## HISTORIC AND DESIGN REVIEW COMMISSION

July 15, 2015

**HDRC CASE NO:** 2015-288  
**ADDRESS:** 239 / 241 / 243 CENTER  
**LEGAL DESCRIPTION:** NCB 580 BLK 11 LOT 17 (SUNSET CENTER STREET SUBD) 2012-NEW ACCT PER SPLIT PER PLAT 9621/133-135 FILED 3/11/2011  
**ZONING:** D, H, HE  
**CITY COUNCIL DIST.:** 2  
**DISTRICT:** St. Paul Square Historic District  
**LANDMARK:** Guenther, Colin Building  
**APPLICANT:** Pam Carpenter/Seventh Generation Design  
**OWNER:** Zachry Realty  
**TYPE OF WORK:** Demolition and new construction of multi-family building  
**REQUEST:**

The applicant is requesting conceptual approval to:

BASEMENT FLOOR PLAN - PROPOSED SELECTED DEMOLITION

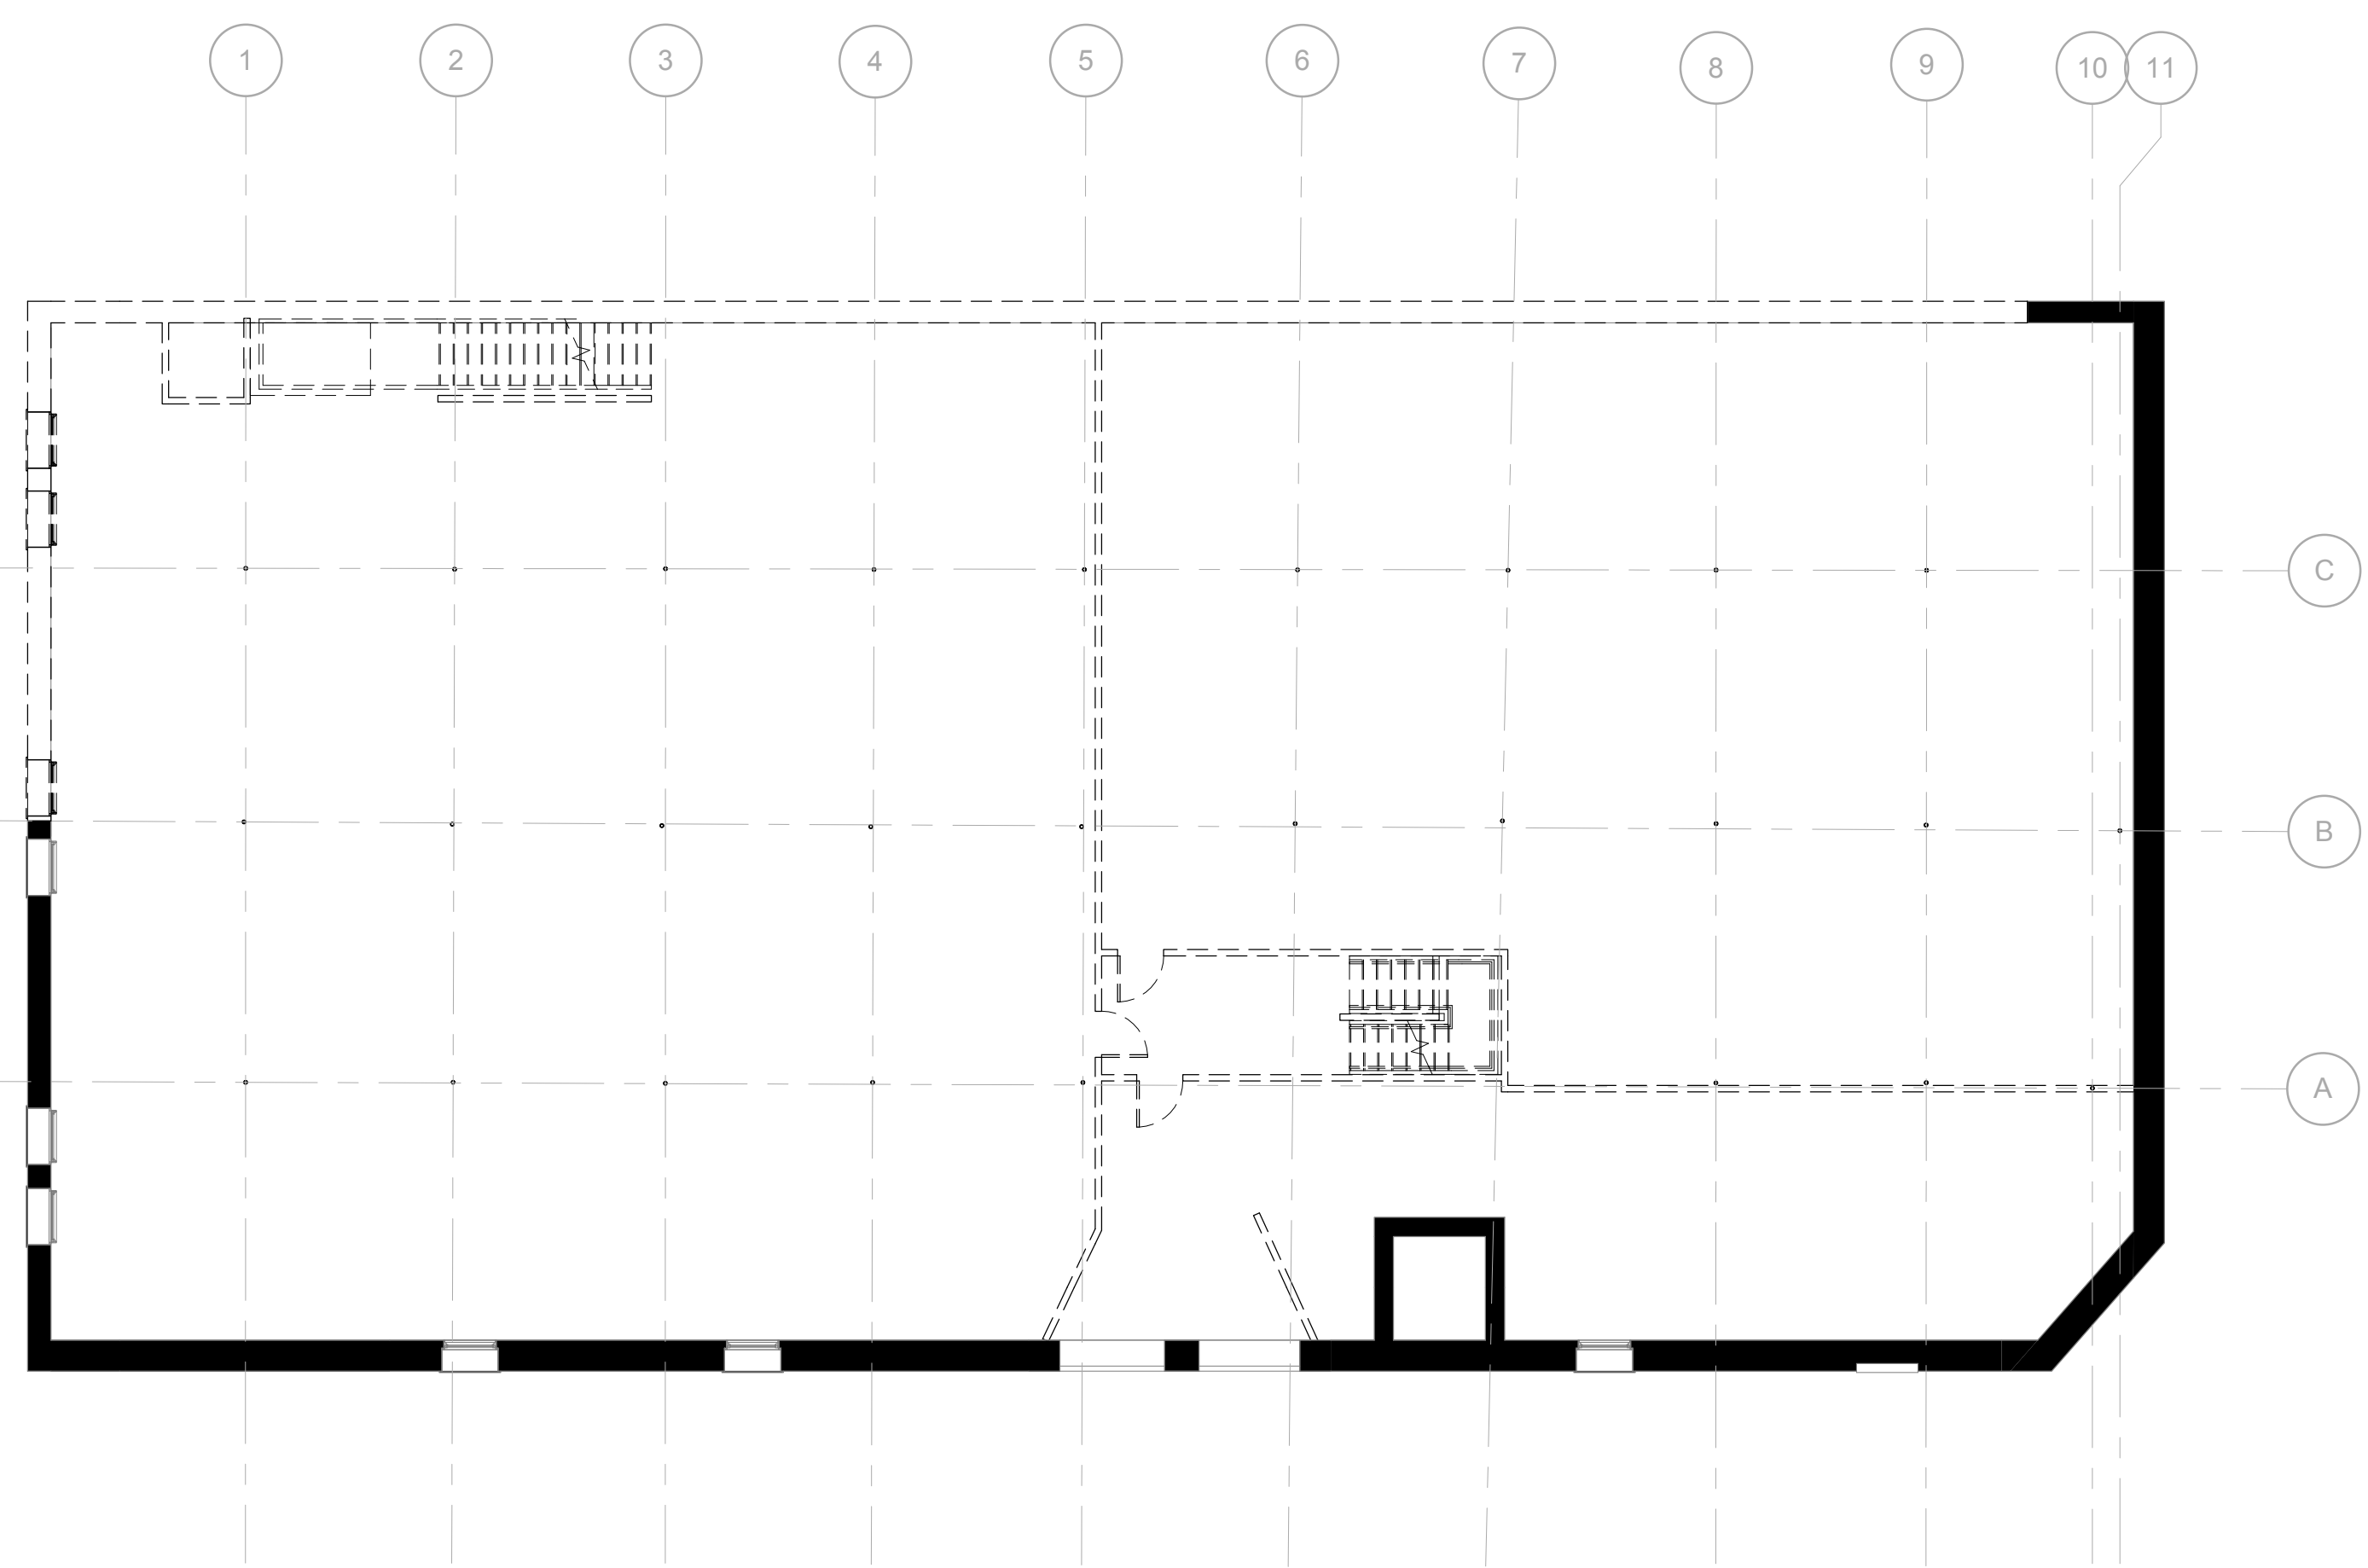
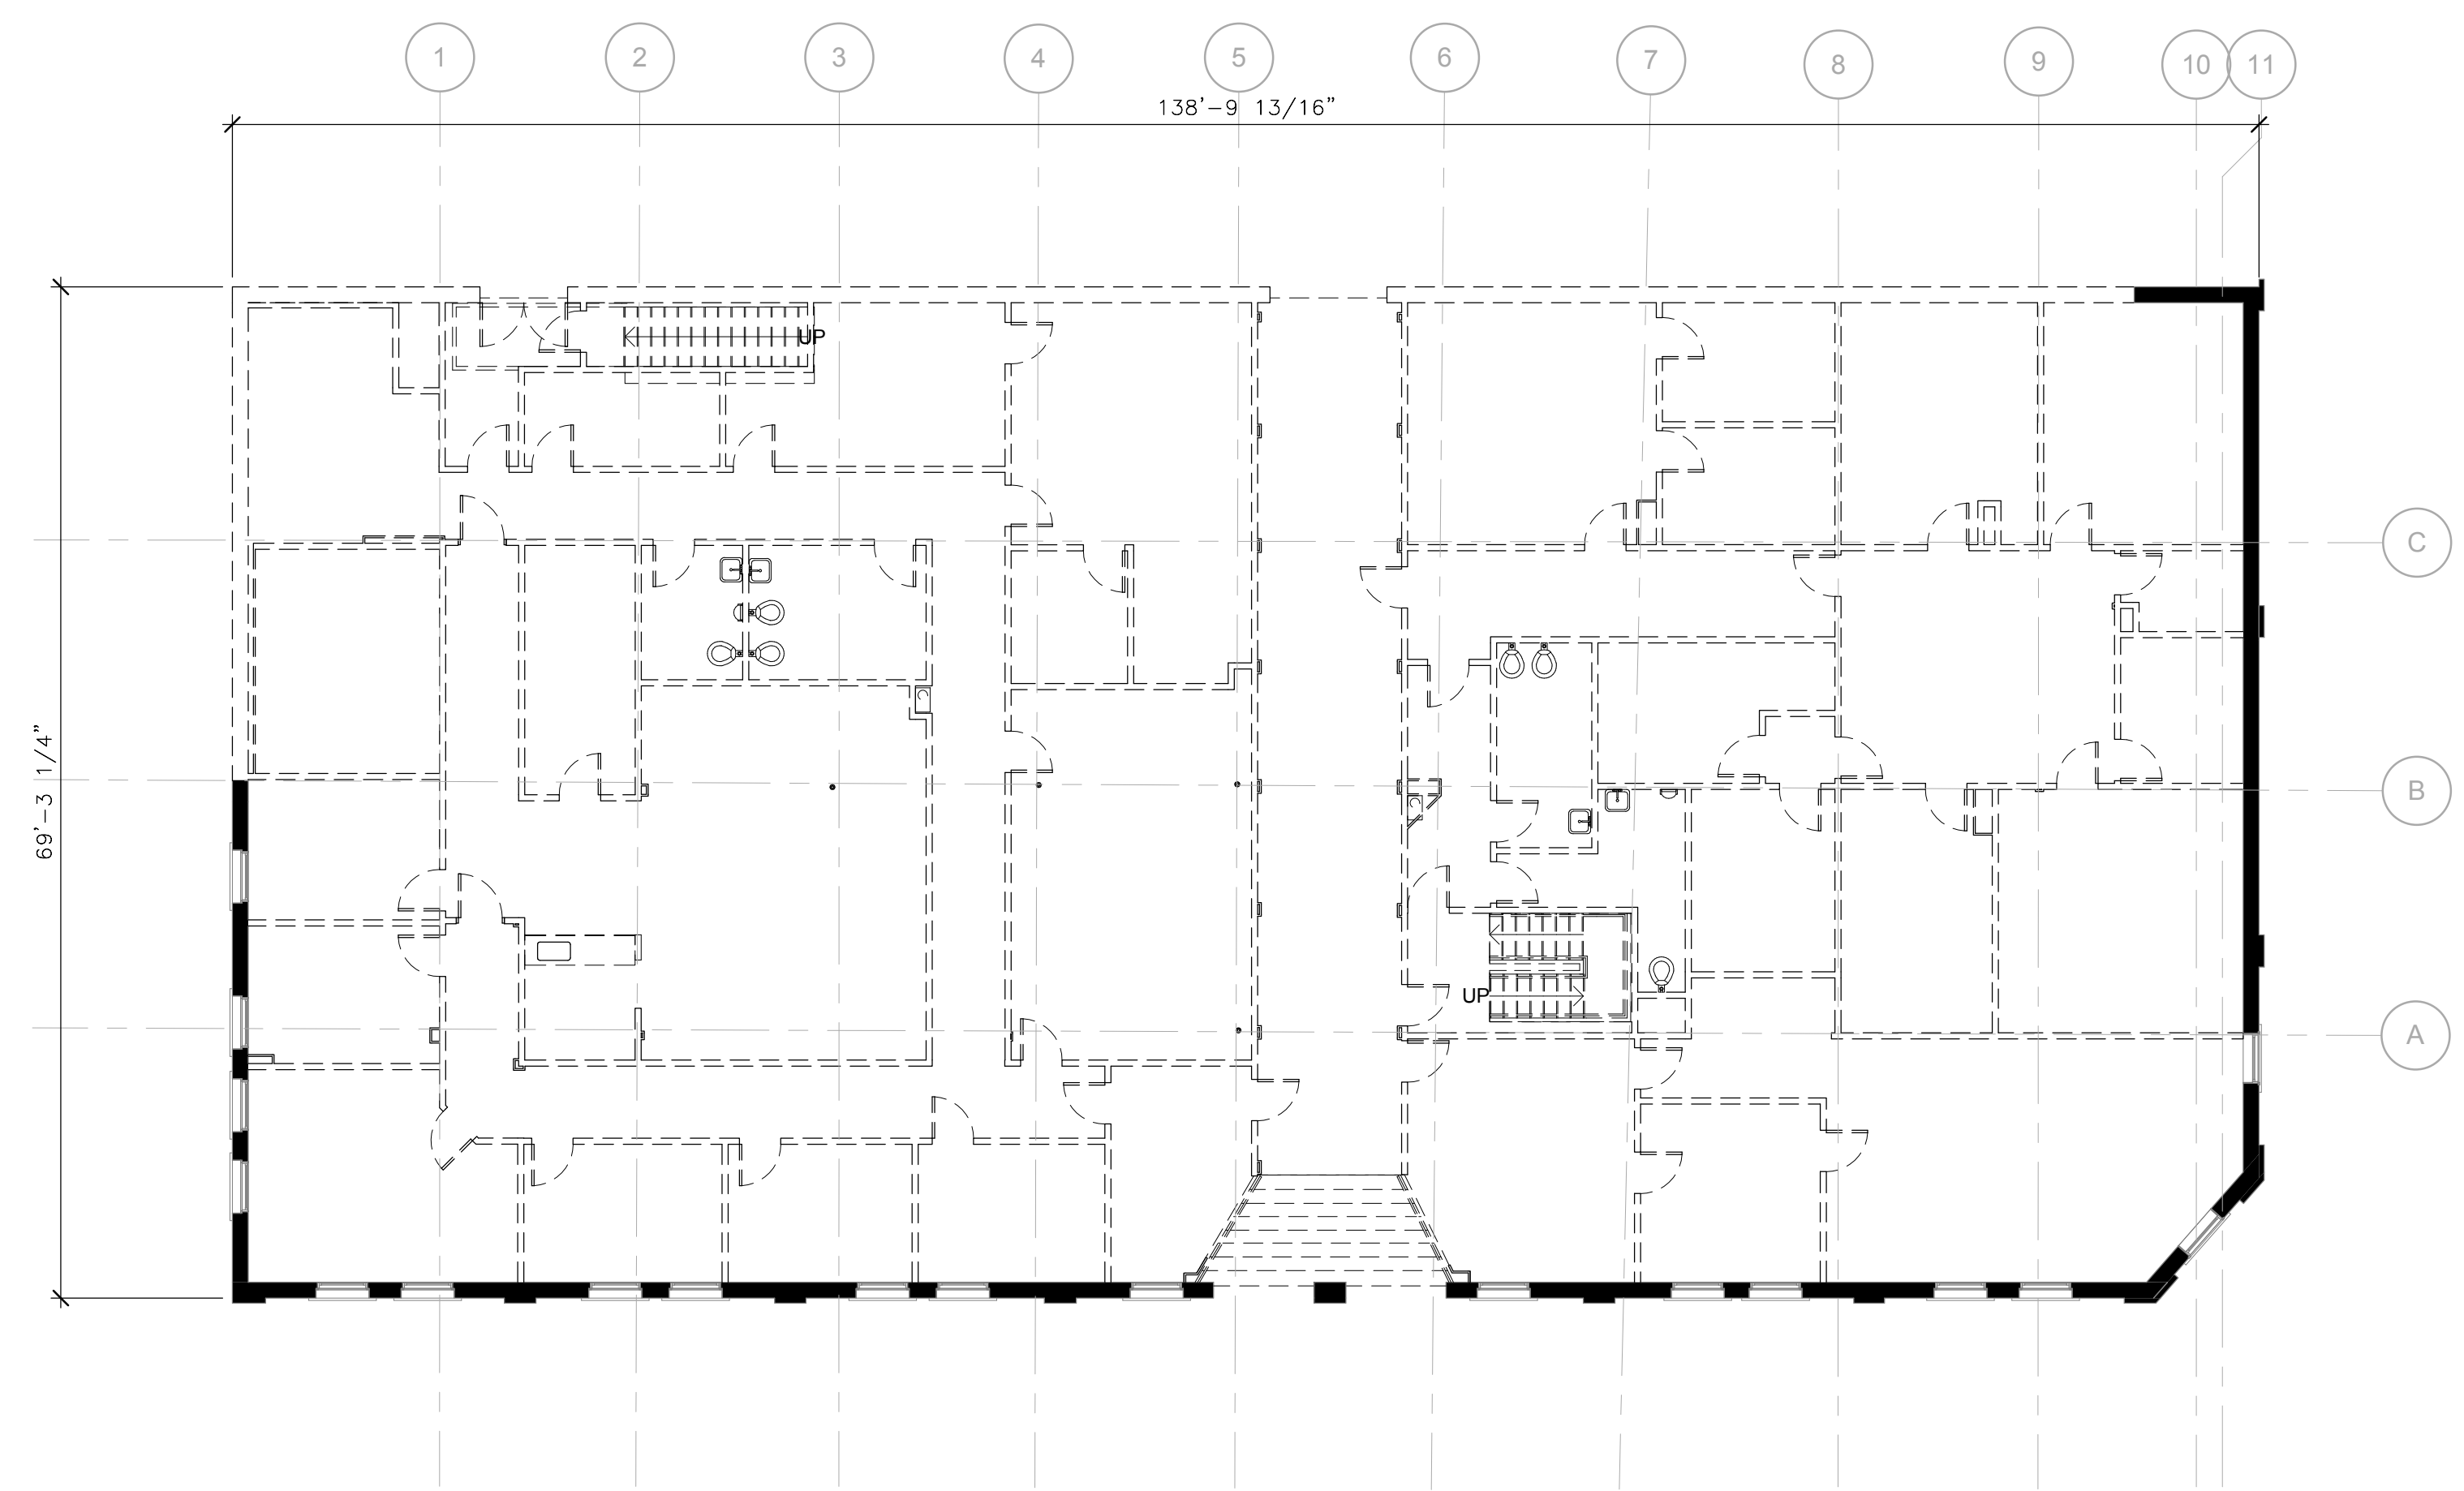
- 1a. 243 Center, commonly known as the Collins-Guenther Building was constructed circa 1910 and is a local historic landmark featuring the zoning designation of HE, Historic Exceptional. The applicant has proposed to partially demolish approximately 95% of the north façade and approximately 40% of the west façade of the Collins-Guenther Building to accommodate the integration of new construction on the site. The south and east facades will remain intact. Over time, the Collins-Garden Building has been stripped of much of its interior architectural detailing as well as undergone various north and west façade modifications including underpinning with CMU walls and cast in place concrete.

- 1b. The applicant has provided a structural assessment of the facades and structure of 243 Center. According to that report, there is considerable water damage at the south, east and west facades and cracking in the masonry of each, deterioration and displacement of brick masonry in the basement, possible failure of the roof membrane, and the potential for minimal foundation damage, however the report states that the masonry facades of the east, south and west facades can be preserved and that damage to the other listed structural elements can be corrected.

- 1c. Staff finds that the demolition of the north wall and west walls, much of which are blank and are structurally compromised is appropriate given the applicant's proposal for the adaptive reuse of the Collins-Guenther Building. Staff recommends that the applicant retain any historic masonry materials that can be used in the rehabilitation of the structure or in the construction of the new structure.

- 1f. As mentioned in the provided façade and structural report, the applicant has proposed to fill the basement level to accommodate for additional height of a new structure. The applicant has noted that the safe door and cast iron columns will be salvaged for reuse. Given the existing state of much of the interior of the structure as well as the need for a substantially stronger foundation for added density, staff finds this request appropriate.

- 1. Staff recommends conceptual approval of request item #1 based on findings 1a through 1g with the stipulation that

the applicant salvage any original brick, timber or steel materials that can be reused in the construction or detailing of the proposed new construction.
